REPLY UNDER 37 CFR §1.116
EXPEDITED PROCEDURE
TECHNOLOGY CENTER 2800

| For: A High Voltage Semiconductor | § | Examiner: Budd, Paul A. |
| Device Utilizing A Deep Trench | § | |

AMENDMENT AFTER FINAL

Fig. 2

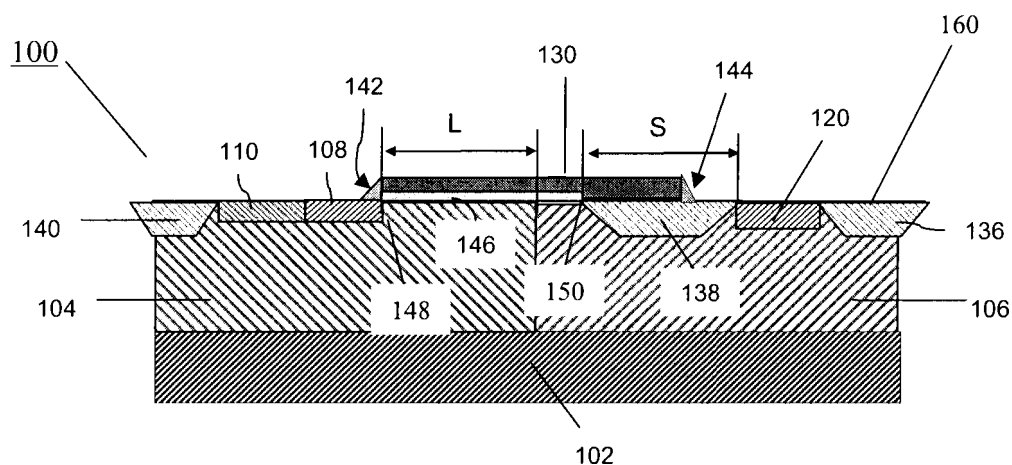
Applicant has corrected the title of each of the drawings and amended Figures 2 and 3. Replacement Sheets are attached.

The title of each of the drawings has been corrected per the Examiner's suggestion. Figures 2 and 3 have been resubmitted with hatching per the Examiner's suggestion. Additionally, in Figure 3, reference numeral "140" has been amended to "142," reference numeral "142" has been amended to "144," and reference numeral "144" has been amended to "146." Figure 3 has been amended to be consistent with Figure 2 and the description in the Specification. No new matter has been added.
